RE: CONCORD AVENUE – WATER MAIN, STREET & SIDEWALK
RECONSTRUCTION – FILE NO. 5150

ADDENDUM NO. 1

**Concord Avenue
Addendum #1
February 9, 2010**

TYPICAL BUTTERFLY VALVE AND BOX DETAIL
NTS

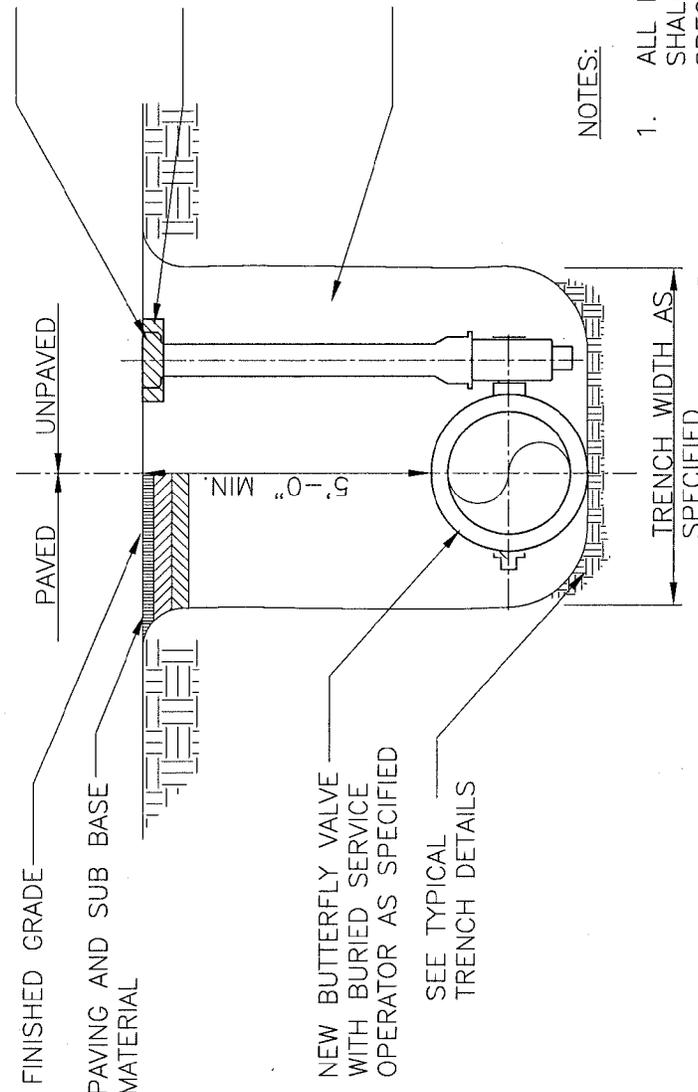
Delete the "Typical Butterfly Valve and Box Detail" and replace it with Sketch SK-2 "Typical Butterfly Valve and Box Detail"

TYPICAL BUTTERFLY VALVE AND BOX DETAIL

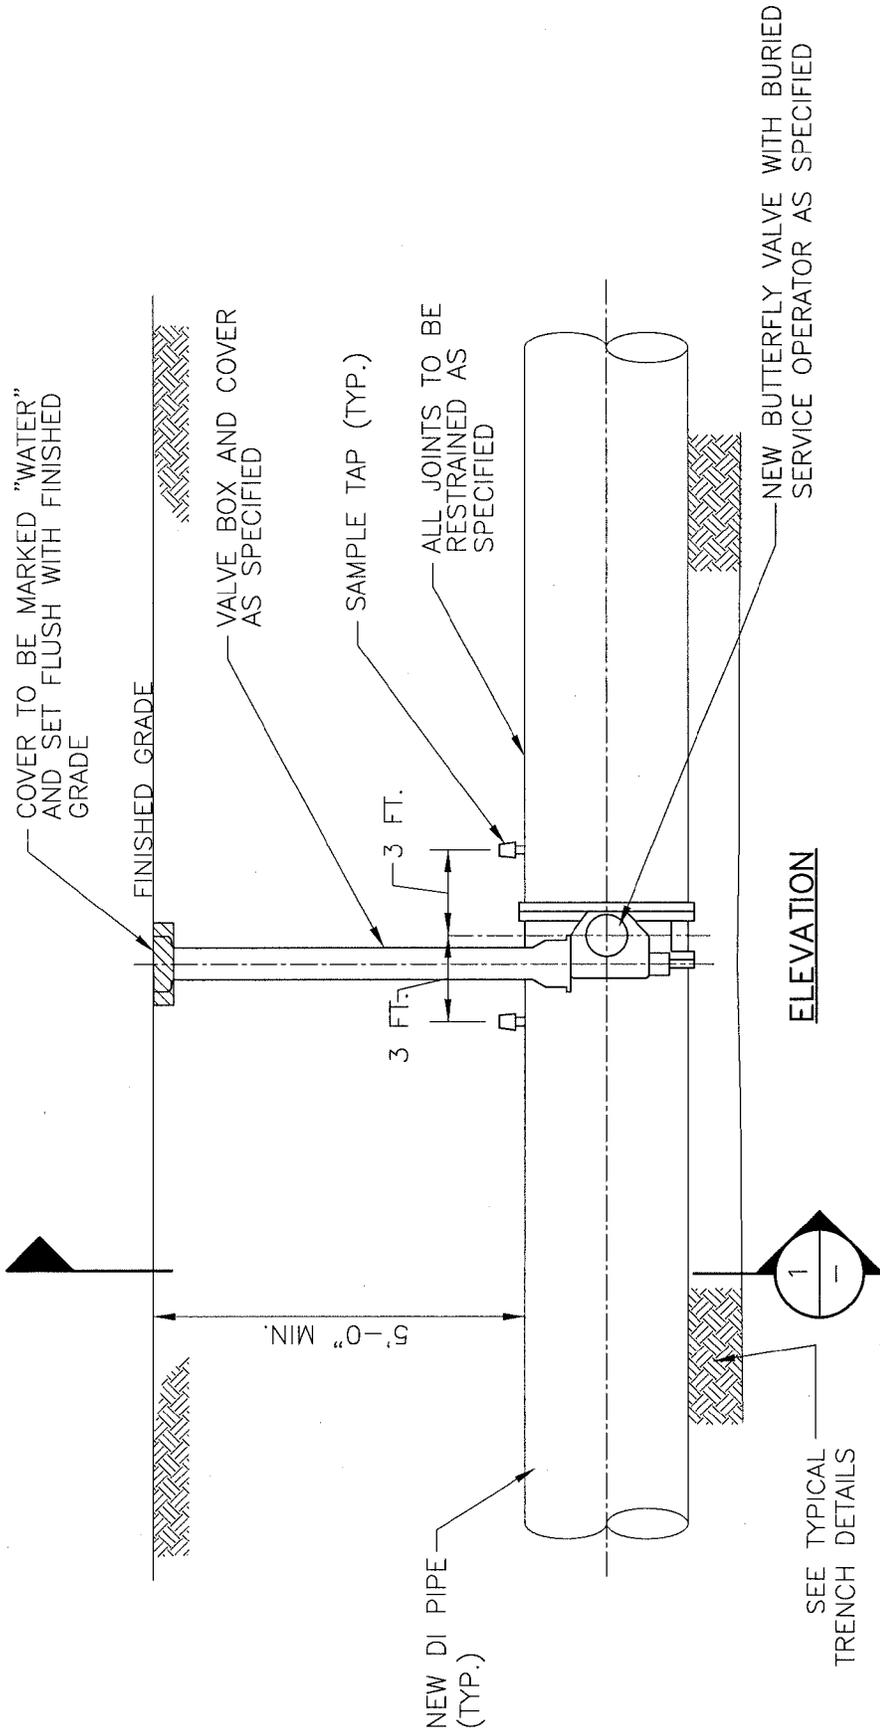
Add Sketch SK-3 "Typical Butterfly Valve and Box Detail – Elevation"

NEW SERVICE CONNECTION TYPICAL DETAIL

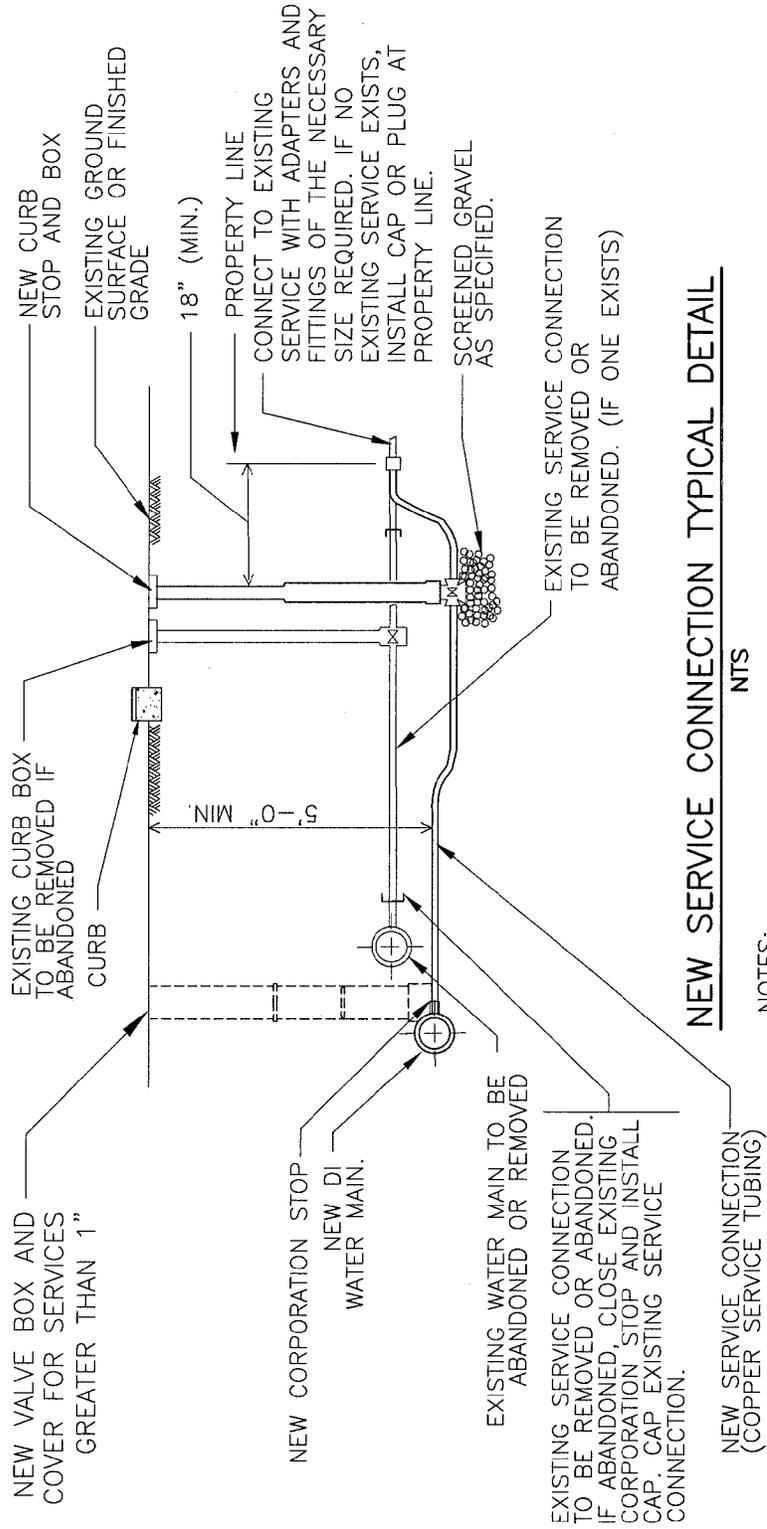
Delete the "New Service Connection Typical Detail" and replace it with Sketch SK-4 "New Service Connection Typical Detail"

CONNECTION TO EXISTING SERVICE TYPICAL DETAIL

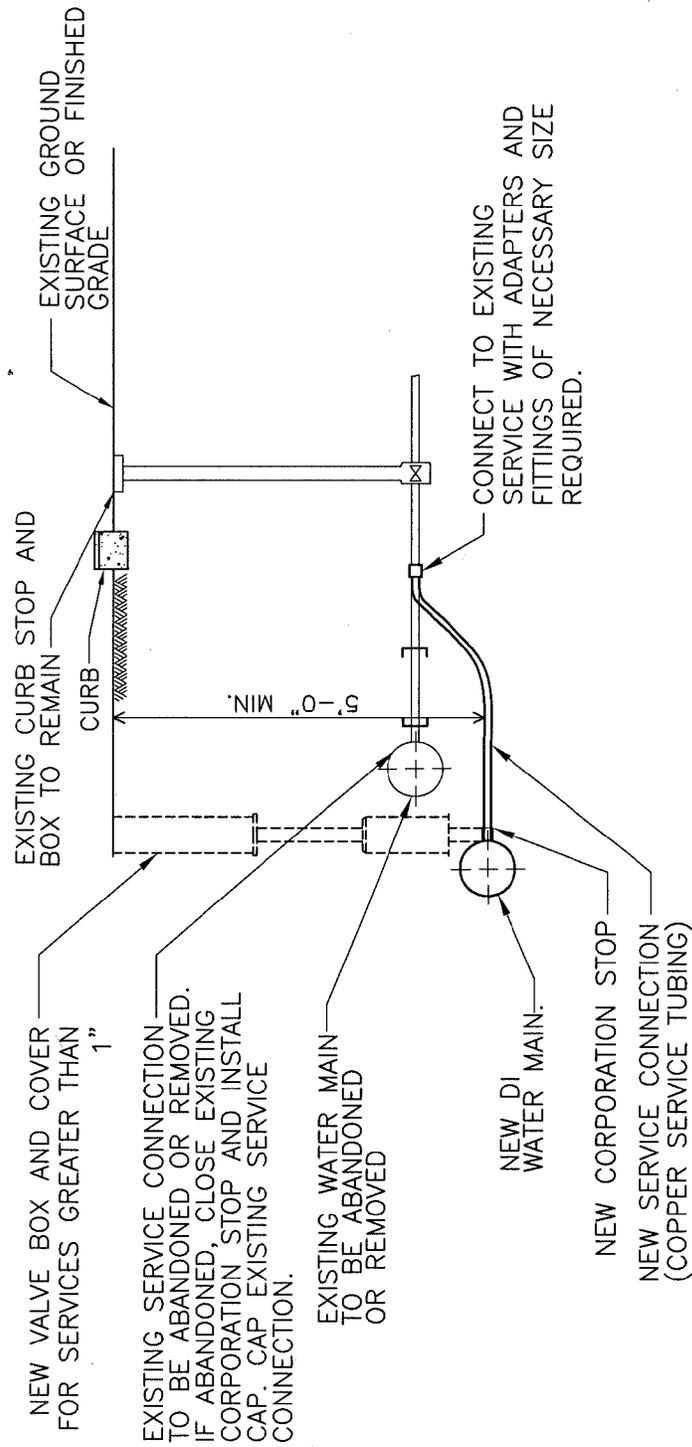
Delete the "Connection to Existing Service Typical Detail" and replace it with Sketch Sk-5 "Connection to Existing Service Typical Detail"

TRENCH AND PAVEMENT RESTORATION DETAIL
 FOR LATERAL WATER MAIN AND SERVICE TRENCHES
 (12" DIAMETER AND SMALLER PIPES)

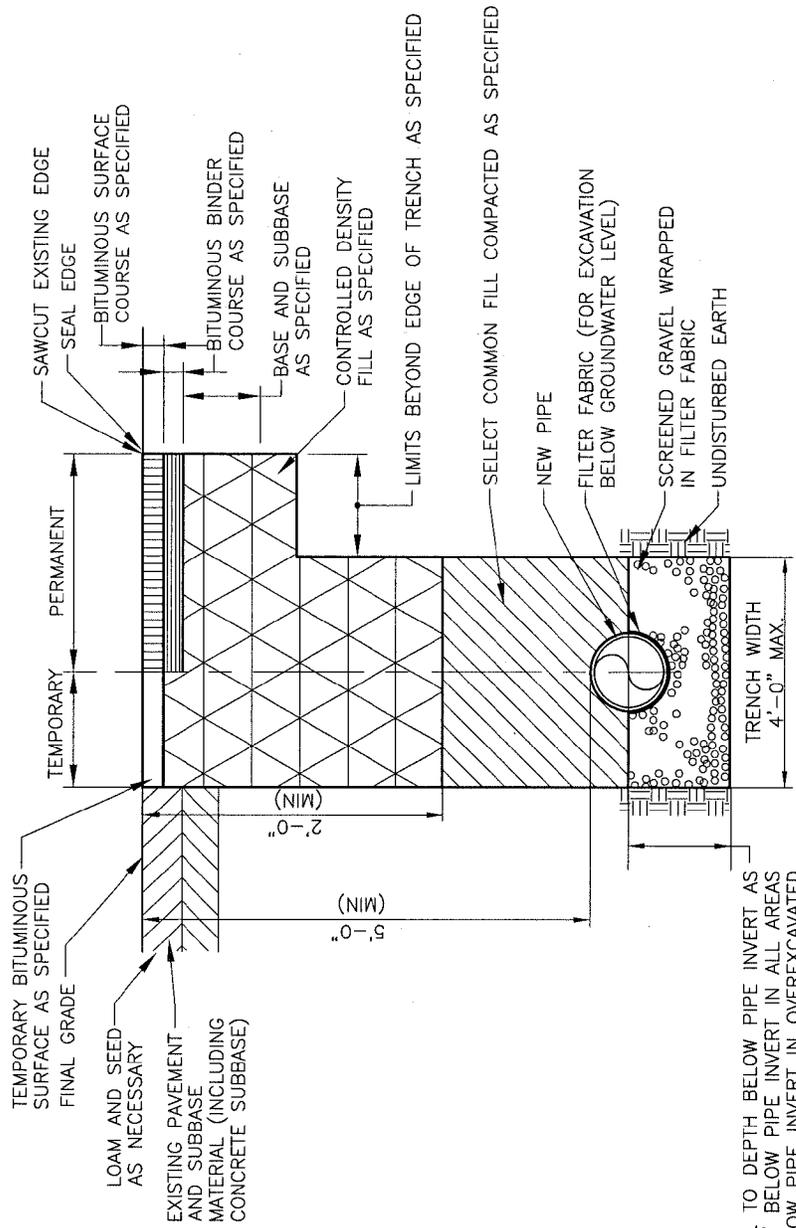
Delete the "Typical Trench and Pavement Restoration Detail for Lateral Water Main and Service Trenches" and replace it with Sketch SK-6 "Trench and Pavement Restoration Detail for Lateral Water Main and Service Trenches".

11. Revise typical trench restoration details to clarify use of screened gravel.

- a. See Sketches SK-6 and SK-7
- b. Revision to spec:
 - i. Under item 301.60 Construction Methods – General replace the sentence "New pipes should be placed on a bedding of at least 12 inches of screened gravel (as specified herein) below their invert."
 - ii. With the sentence "New pipes should be placed on a bedding of at least 4 inches of screened gravel (as specified herein) below their invert."

TRENCH AND PAVEMENT RESTORATION DETAIL FOR NEW 16" DI WATER PIPE ALONG CONCORD AVENUE

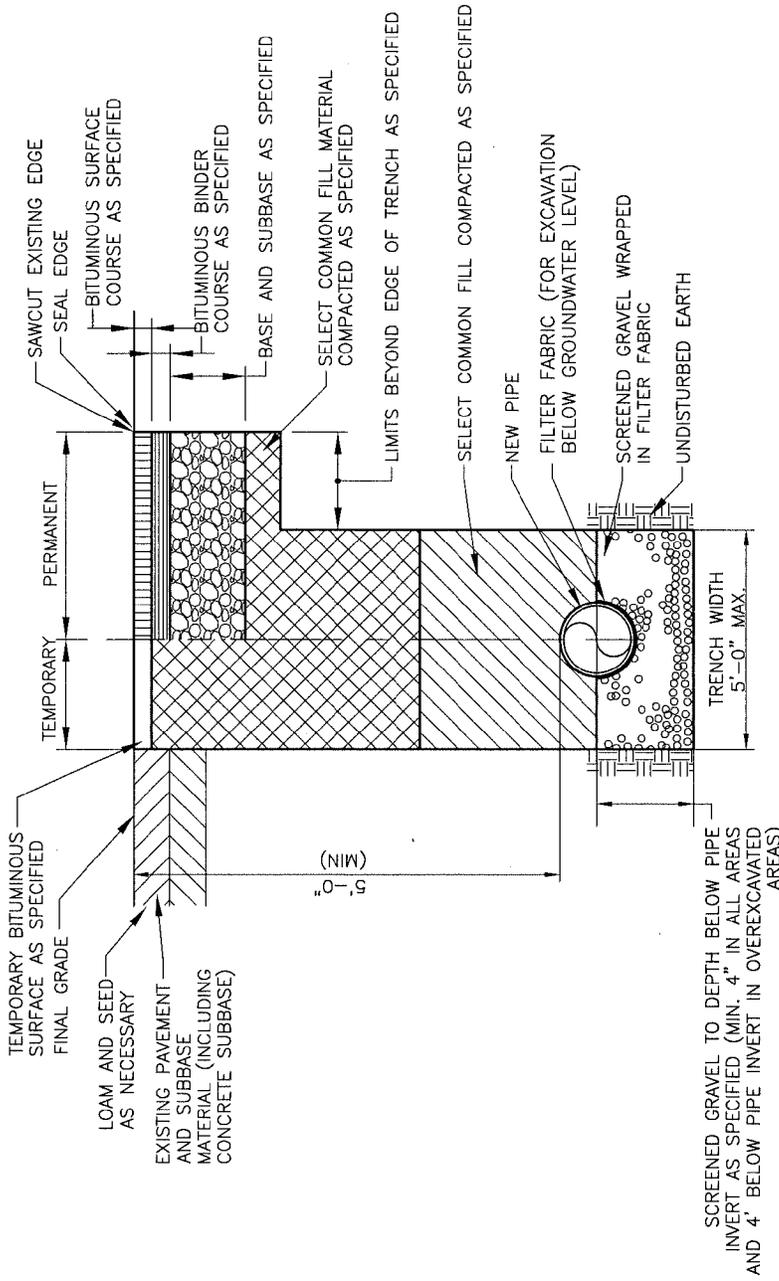
Delete the "Typical Trench and Pavement Restoration Detail for New 16" DI Water Pipe Along Concord Avenue" and replace it with Sketch SK-7 "Trench and Pavement Restoration Detail for New 16" DI Water Pipe Along Concord Avenue".

IRRIGATION CONTROL BOX DETAIL

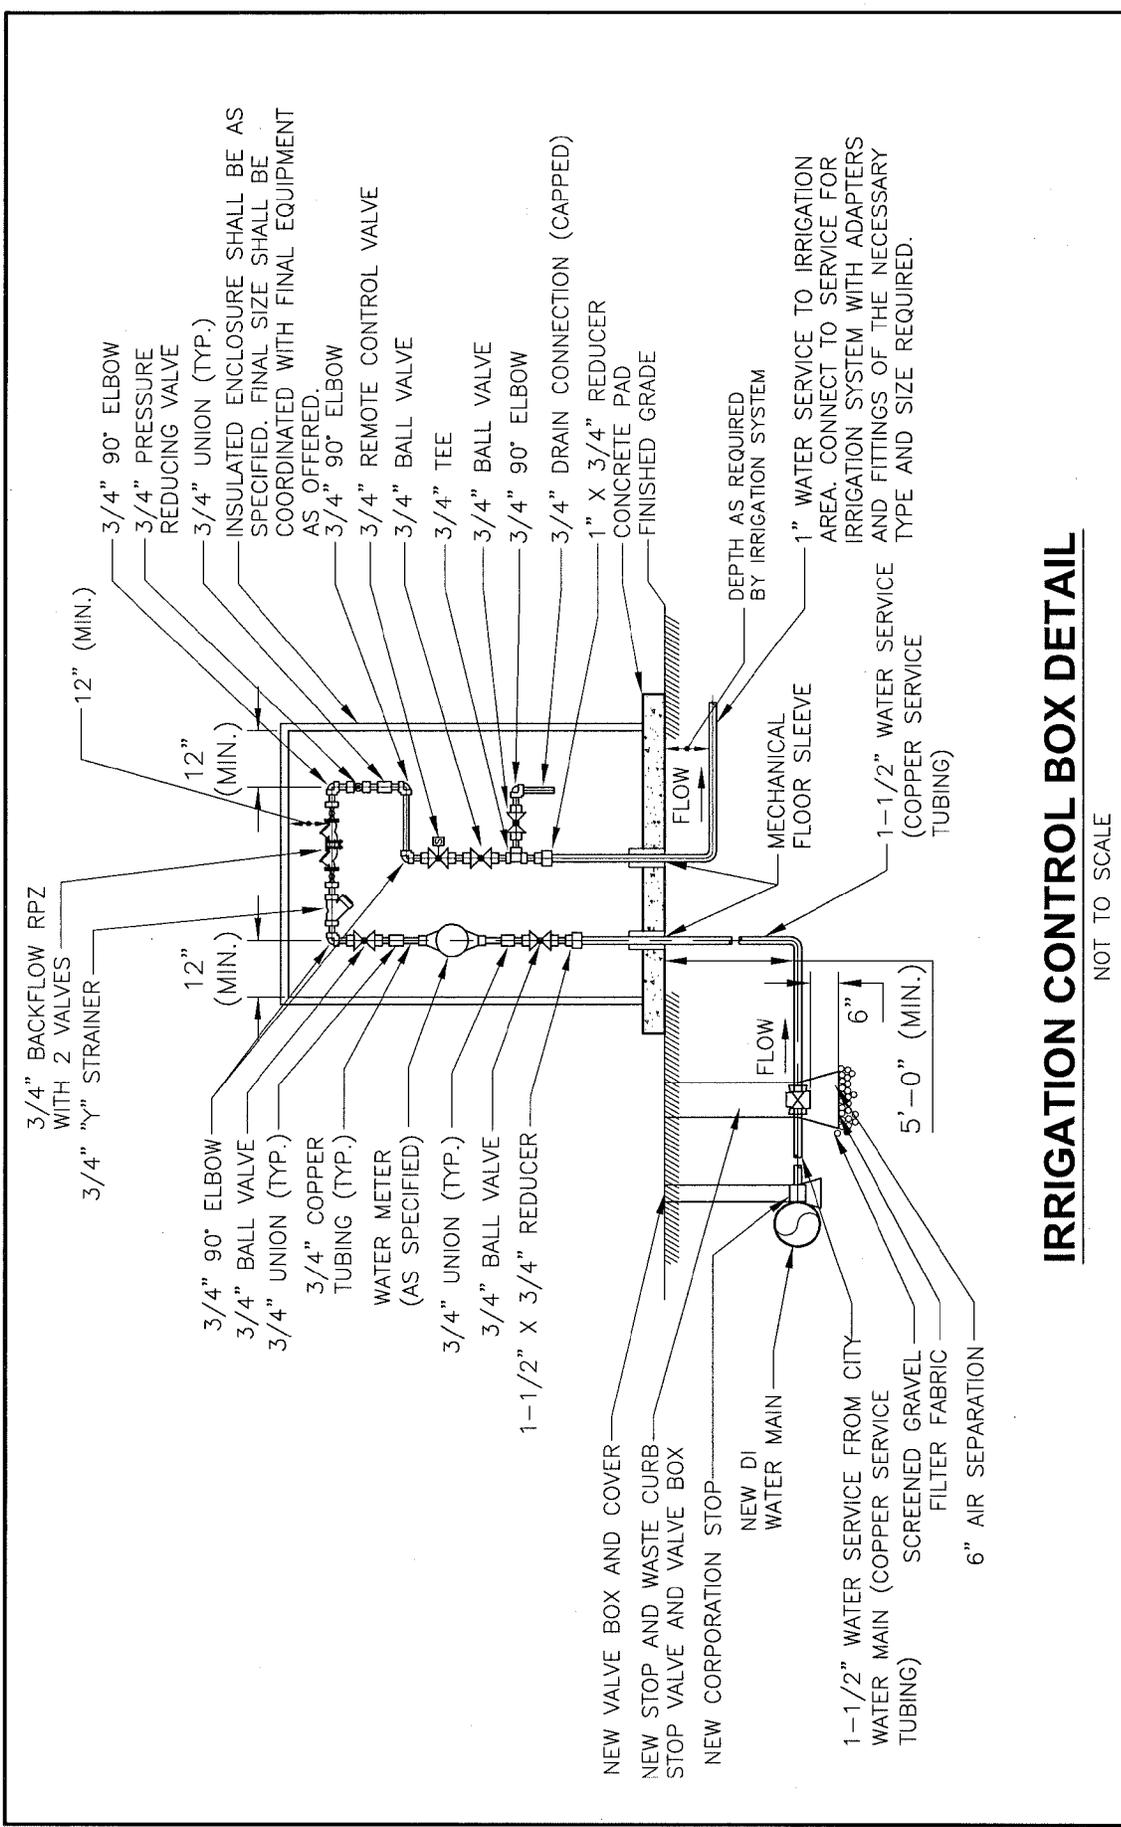
Delete the "Irrigation Control Box Detail" and replace it with Sketch SK-8 "Irrigation Control Box Detail".
